R04HT

3-Point Seat Belt Fasteners

MODELS AFFECTED: 2004 & 2005 A3FE with Option 2836-01, Driver's 3-Point Seat Belt

RECALL

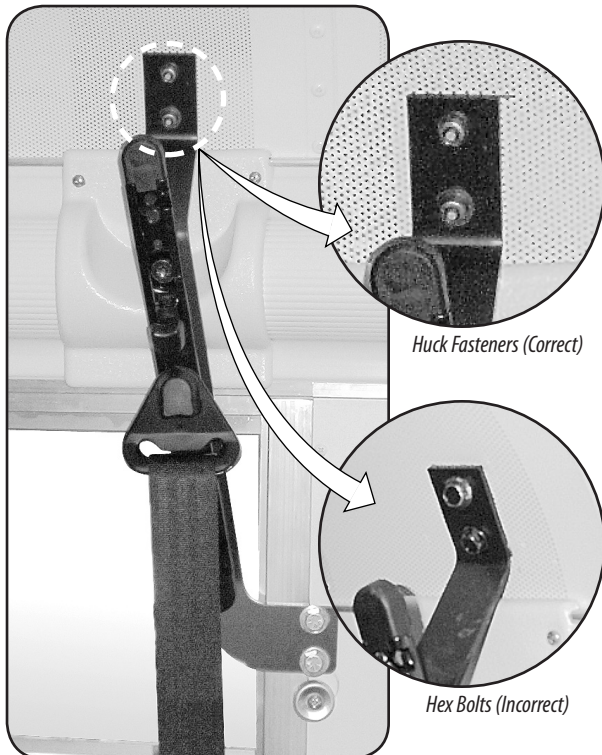
Incorrect fasteners may have been installed in upper mounting bracket of driver's shoulder belt height adjuster.

Inspect the mounting bracket fasteners. If the incorrect fasteners are installed, replace with new correct fasteners.

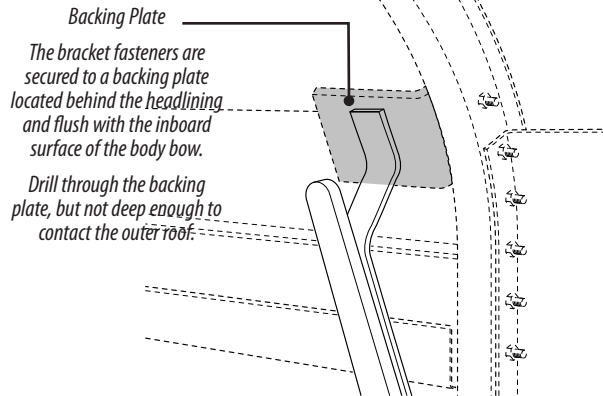
1 Locate the 3-point driver's belt height adjuster mounting bracket assembly, behind the driver's window. The lower part of the bracket assembly attaches to the bow and the upper part to the headlining. The two upper holes of the bracket must be attached with a Huck rivet. If there are two Huck rivets installed, no further action is required. If one or two hex head screws have been installed, proceed to replacement procedures below.

2 Remove the seat belt height adjuster bolts, using a T50 Star Bit Socket/Torx Head Bit socket.
